Landmarks Commission

Agenda Item: 5
Case # SI-2020-00003
Project # PR-2019-002579
February 12, 2020

Staff Report

<i>Agent</i>	
<i>Applicant</i>	JMP Works LLC
<i>Request</i>	Certificate of Appropriateness for New Construction
<i>Legal Description</i>	Lot 26 Coronado Place Addition
<i>Address/Location</i>	1027 Forrester St. NW
<i>Size</i>	0.34 Acres
<i>Zoning</i>	R-1A
<i>Historic Location</i>	Eighth & Forrester Historic Preservation Overlay Zone

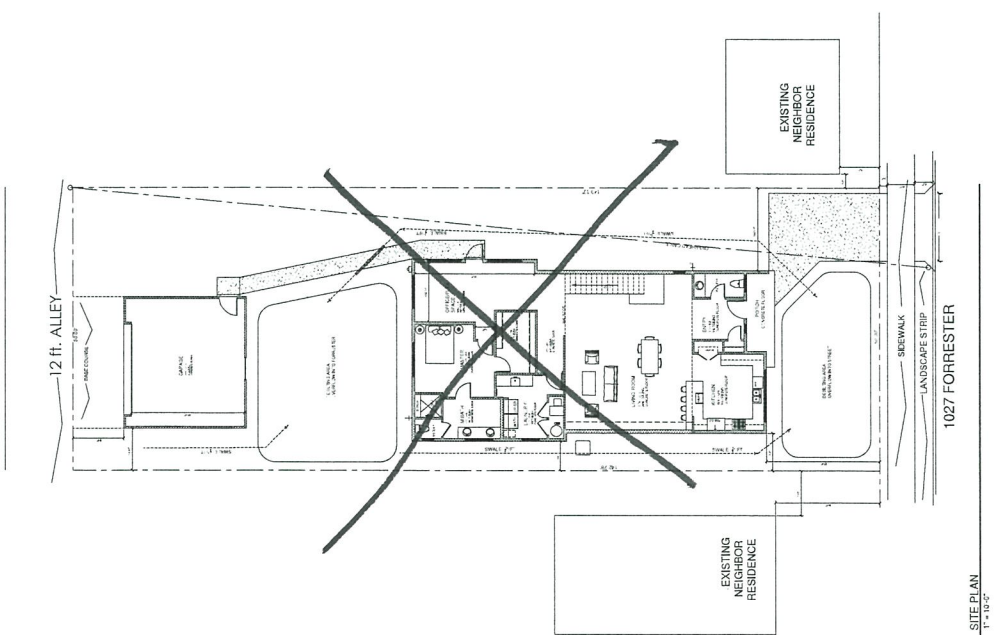
A garage with rear alley access is proposed. As this is available and practical, it is considered to be the preferred location of resident parking. The proposed curb cut from Forrester with a front yard parking pad is not in keeping with the neighborhood or the IDO. (The applicant has removed the front curb cut and drive pad.)

Access to the garage is through the alley, therefore, the addition of a curb cut and parking pad in the front setback is unnecessary. The location would require relocation of a utility pole which may or may not be possible. It is acknowledged that many houses in the neighborhood have garages but this lot does not. If approval for the utility pole relocation is granted then the driveway should extend to the side of the house so cars would not be parked in the front yard setback.

FRONT ELEVATION
 1/4" = 1'-0"

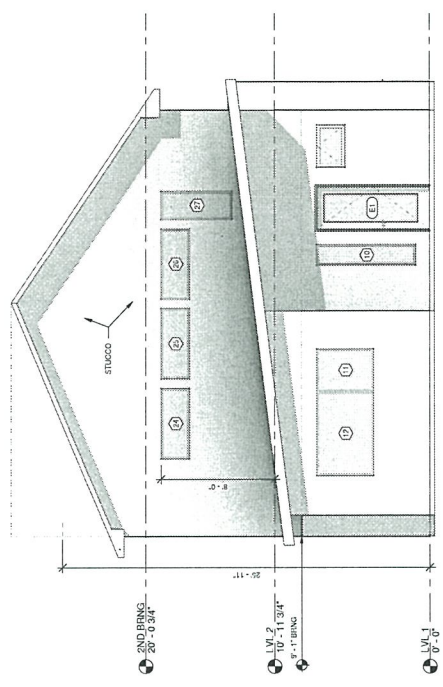
While the sense of human scale is evident, with a single-story front, window recesses are not evident and the proportions and placement of windows are not in keeping with those typical in the neighborhood. (The applicant has submitted an alternative showing windows to be recessed.)

Windows should be recessed a minimum of 4 inches to provide depth and shadow similar to traditional houses in the neighborhood. The proportions and rhythm of windows are undermined by the use of ribbon windows along the upper level of the front elevation. Such windows would be appropriate for a mid-century infill project but do not reflect the character of 8th & Forrester.

The large front window combination is not very different from the pattern of screened-in front porches that predominate Forrester St. On the upper level, the group of ribbon windows across the front does not maintain the window patterns of the neighborhood, nor is it necessary for the functioning of the interior space. Second-story windows to the south are large double windows which do not reflect the rhythm or proportion of the, predominantly sash, windows of the neighborhood; however, being to the side, they do not have a negative affect on the neighborhood character.

The single-story portion of the building which is the street front presentation, has a shed roof rising from south to north. Such a roof profile is inconsistent with the style of houses in 8th and Forrester Historic District and should be reconsidered.

While contemporary interpretation is permissible within the HPOs, elements of this project as mentioned previously, have over-reached the level of compatibility. Door and windows show no use of trim, nor are there railings at the balcony.

1. Applicant is responsible to acquire, and approval is contingent upon, all applicable permits and related approvals.
2. Approval is contingent upon the following design amendments:
 - a) Windows to be recessed a minimum of 4 inches
 - b) Removal of ribbon windows to be replaced with more appropriate window proportions
 - c) Reconfiguration of single-story roof to remove side sloping shed roof
 - d) Removal of vertical fiber cement panels
 - e) Replacement of roof material with shingles
 - f) Submission of full door and window schedule for approval
3. Applicant shall provide LC staff with drawings detailing the required design amendments.

1027 FORRESTER FRONT ELEVATION WITH DESIGN AMENDMENTS EXHIBIT A

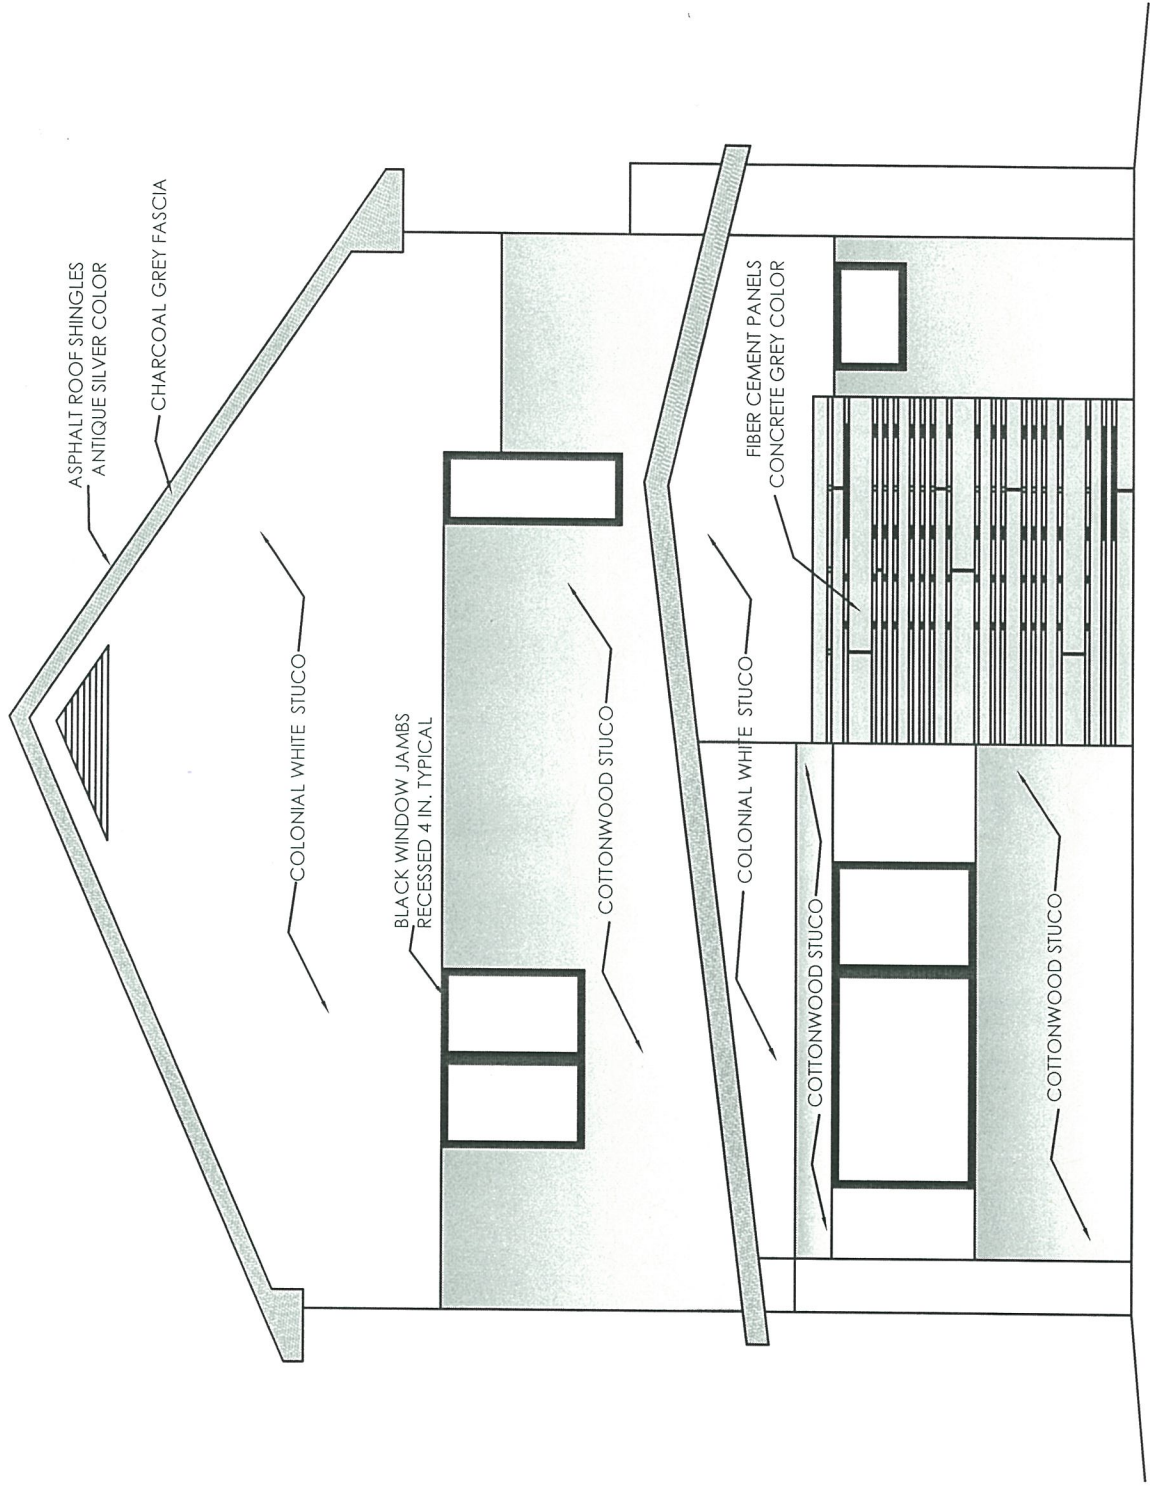
The proposed roof is corrugated metal. Such metal roofing- corrugated, standing seam- are not permissible in the 8th & Forrester HPO. A metal roof resembling tiles has been approved by the Landmark Commission; otherwise, the roofing material will need to be changed to an asphalt shingle. (The applicant has changed the roof material to asphalt shingles.)
